# Comments Requested on a Notice of Proposed Rule Making for the Modification of Class D Airspace & Establishment of Class E Airspace at San Bernardino International Airport (SBD)

## ***Background- Summary of Airspace Change Proposal - FAA’s July 2, 2024 , Memorandum, Subject: Revised Airspace Review – SBD***

## **Redlands Airport Association Assessment of the Airspace Change**

### Proposed SBD Class D Expansion and Class D Shelf

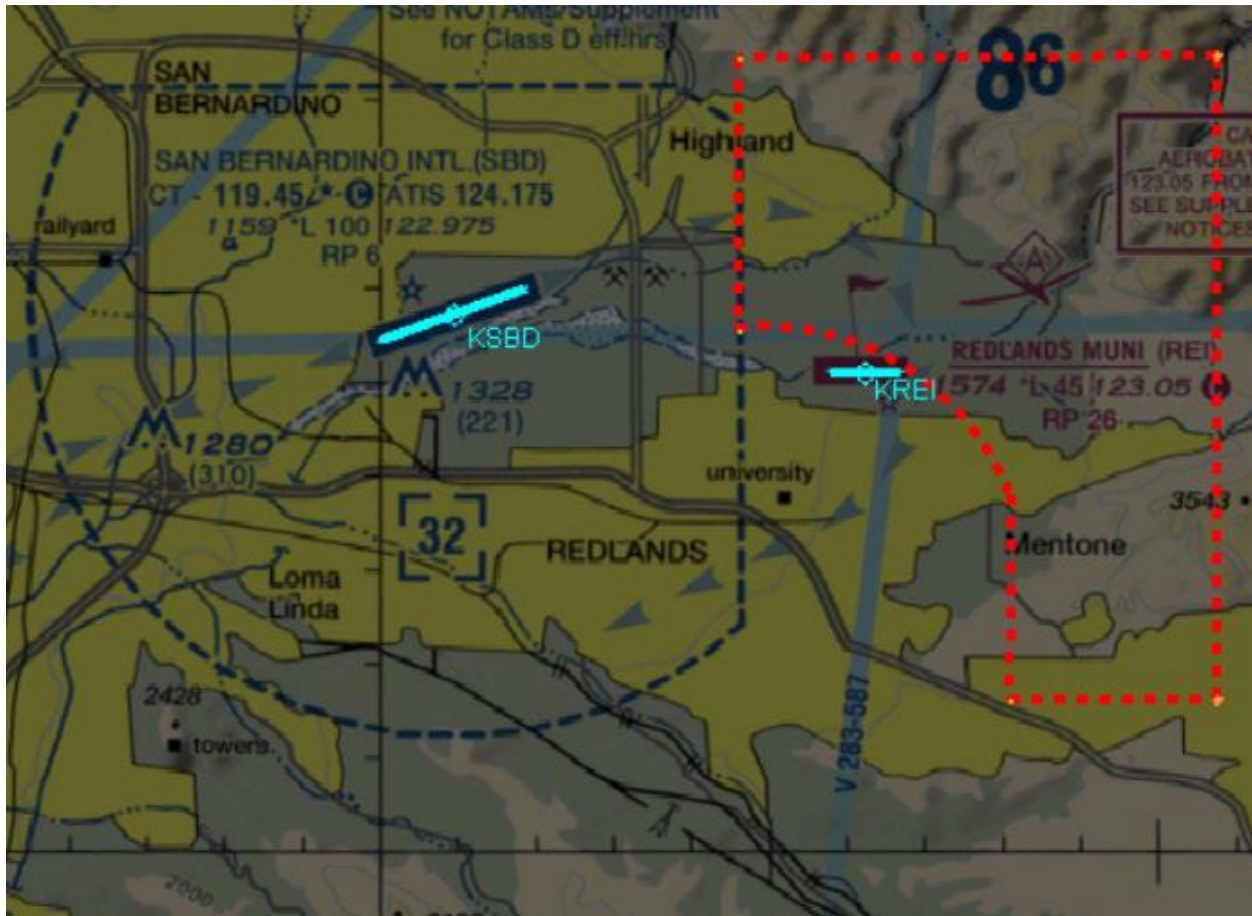
*-The published TPA at REI is 2503'. That provides less than 100' separation from the floor of the newly proposed Class D shelf. This may lead to airspace incursions or REI traffic flying at a lower pattern altitude.*

## Proposed Charting of Expanded Class D and E Airspace

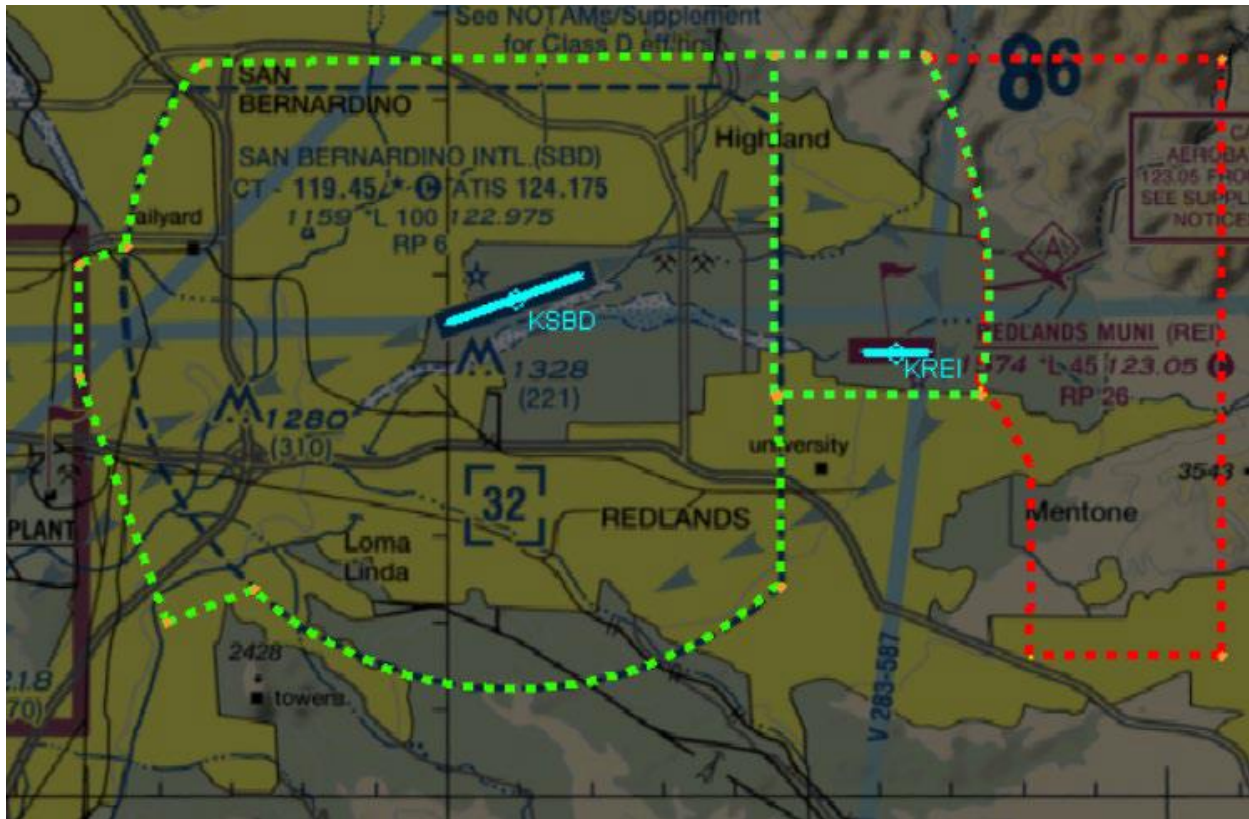
*- The proposed charting of the expanded Class D and E airspace does not depict the location of the E4 airspace under the new Class D shelf. Standard charting symbology depicts Class E surface area with a magenta dashed line. The magenta line should replace the dashed red line in this drawing and extend under the class D shelf. To the eastern boundary of the new Class D surface area.*
